Customer / Dealer Advisory

Subject: Corroded Battery Cables

Models Affected: Specific Freightliner New Cascadia vehicles manufactured with sales datacode 290-1D3

Fig. 1 Batteries with cover pad

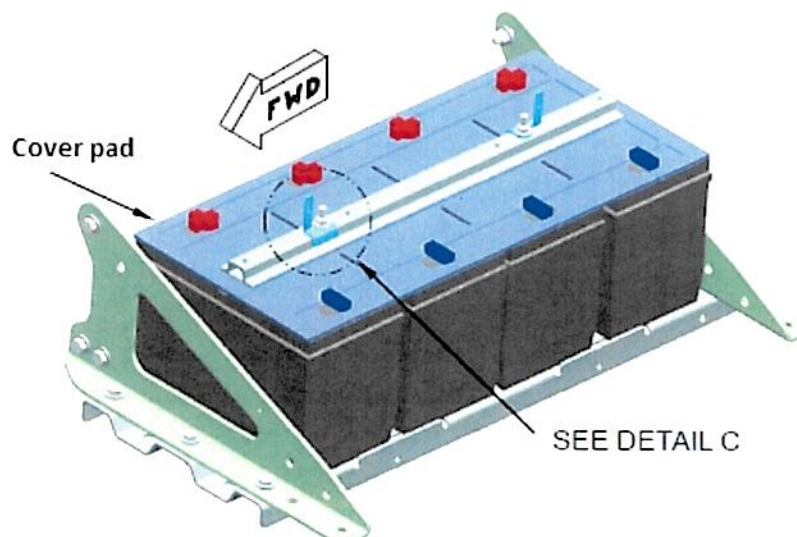
IMPORTANT: This document is intended for use only for an "as needed" guide for vehicles operating in conditions of extreme road salt. The current datacode of 290-1D3, Steel battery box with enclosed tray, utilizes a pad on top of the batteries. This mentioned pad will be relocated under the batteries to avoid moisture entrapment and resulting cable corrosion.

1. Park the vehicle on a level surface, shut down the engine, and set the parking brake. Chock the rear tires.
2. See the diagram below. Note the pad, part number 66-01226-000:

4. Remove battery cover pad part number 66-01226-000. Remove batteries. Ensure that the battery box base is clean of debris, and place the pad on the battery box base. Reinstall the batteries over the top of the pad.
